Field Inspection Report
Mahoona Dam AK00207
6/10/2011

SUBJECT: Ouzinkie Dam Replacement Conceptual Alternatives

SUBJECT: Replacement of Failing Water Source – Ouzinkie, Alaska

RE: Emergency Measures for stabilizing Mahoona Lake Dam

Picture #1 - 18" PVC Pipe Section Near the Hydroelectric Plant

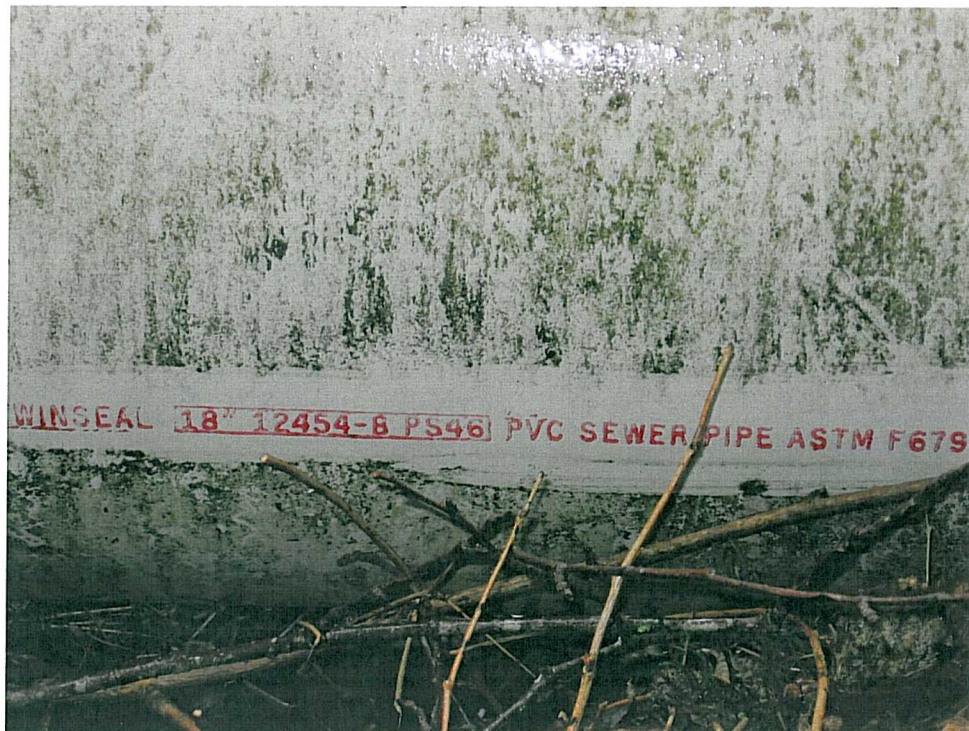
During a field examination of the transmission line on May 10, 2007, a Sr. Civil Engineer at ANTHC noticed certain deficiencies in the transmission line that are serious enough to warrant replacement. An 18-inch PVC non-pressure sewer pipe meeting ASTM F679 was installed as the transmission line (see Pictures #1). ASTM F679 says, "The requirements of this specification are intended to provide pipe and fittings suitable for **nonpressure** drainage of sewer and surface water." Picture #2 shows the pipe is clearly marked ASTM F679. The pipe was poorly covered during construction and has jacked and been pushed through time (see Picture #3). Exposed pipe can be crushed by falling trees as shown in a near miss (see Picture #4).

Though the transmission line has performed adequately over the last 20 years, ANTHC recommends replacing the pipeline. The suggested material is 20" HDPE, DR 11, butt fused connections. This pipe is rated for this water pressure application and has much better freeze/thaw characteristics. Proper installation practices should be followed to provide an adequate bury depth below the frost line and for protection of the pipe.
